MATERIALS LICENSE

SUBJECT: LICENSE AMENDMENT

SUBJECT: LICENSE AMENDMENT
Docket: 030-32444
License: 49-26963-02
Control: 466199

BELLE AYR MINE - PLANT 1:FASTLAB LOCATION

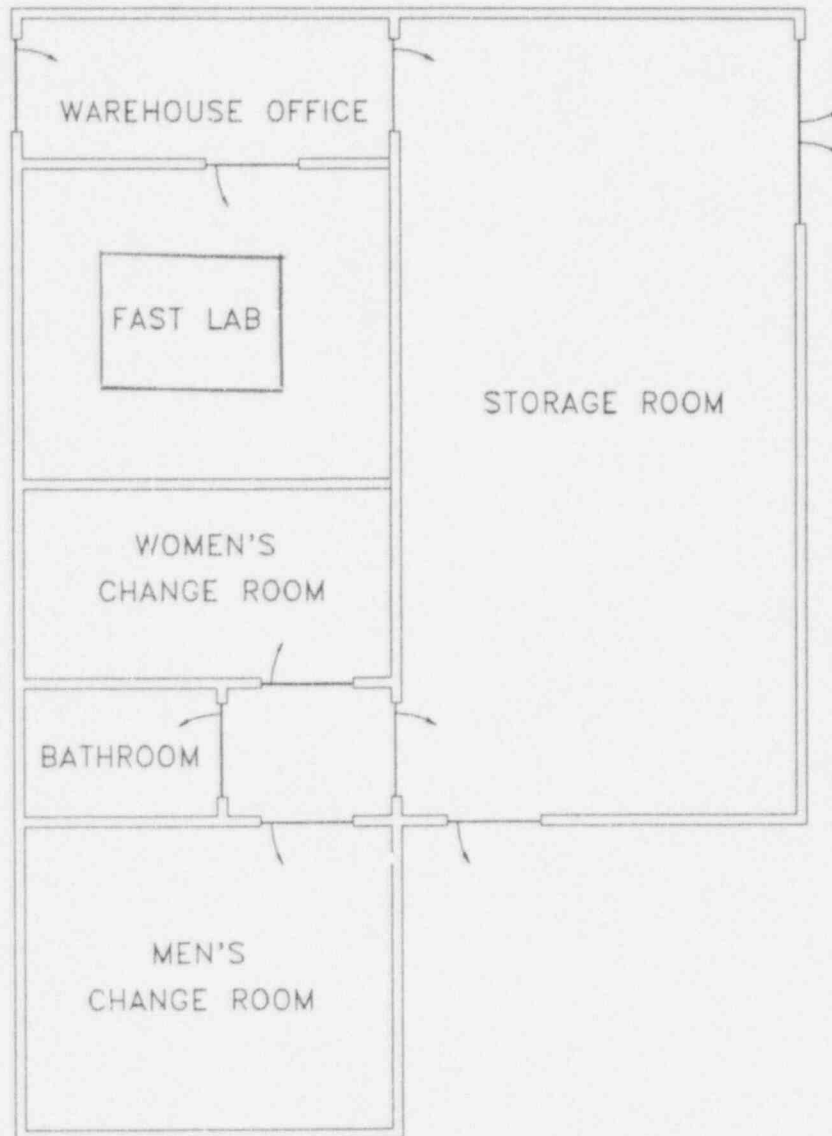
- (a) a sketch of the proposed location of the device within your facility,
- (b) the environmental conditions to which the device will be exposed,
- (c) a description of a cooling system, its maintenance, the method and procedures for detecting a cooling system failure, procedures for coping with a cooling system failure, and the consequences of its failure (if applicable),
- (d) information on the maintenance of the device; and
- (e) emergency procedures to be followed in the event of an accident involving damage to the device.

- a) A sketch of the proposed location of the device within the facility is shown on Exhibit "B" which is attached hereto and by reference made a part hereof.

EXHIBIT "C"

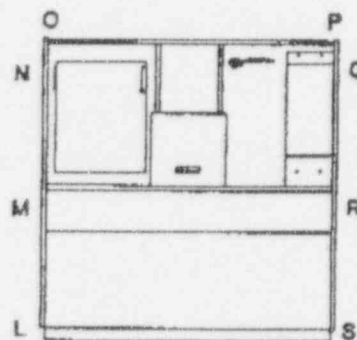
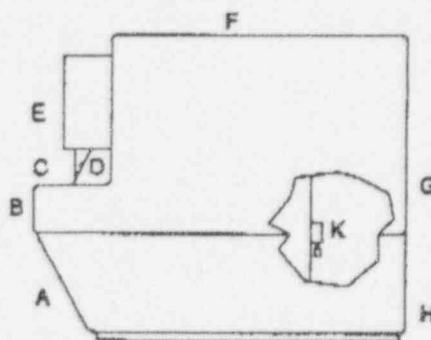
Please provide either (a) documentation of your evaluation that unmonitored users are unlikely to receive doses in excess of 10 percent of the regulatory limit or (b) a commitment for personnel monitoring, including: the name of the supplier of the monitoring equipment you will use or a commitment to use any supplier accredited by the National Voluntary Laboratory Accreditation Program, identification of the type of personnel monitoring equipment that will be used, and specification of the frequency with which personnel monitoring will be exchanged. (NOTE: if you propose to service the device, you should provide personnel monitoring equipment for personnel who perform the service operations.)

According to the manufacturer, Personnel Monitoring Equipment is not required in connection with the GAMMAMETRICS FastLab device. With the exception of only one point, all points on the surface of the device as shown in the accompanying sketch (see Exhibit "C") are at or below .5 mr/hr. The one point higher than .5 mr/hr is point "D" and is the point used for the following calculation. Point "D" is the point of insertion of a bucket of raw material for elemental analysis by an operator. The radiation at this point is 1 mr/hr. Using a scenario of 2 hours per day, 250 days per year exposure to an operator's hands in area "D", the total dose to the operators extremity (hands) would be as shown:

The figures at the right show the FastLab from a side and front view in that order. The position D shown from the side view is the area of 1mr/hr where an operator inserts a bucket for analysis. Typical Operation requires about 2 to 5 seconds every 15 minutes for an operator to insert a bucket. Otherwise all other regions shown are at .5 mr/hr or less.
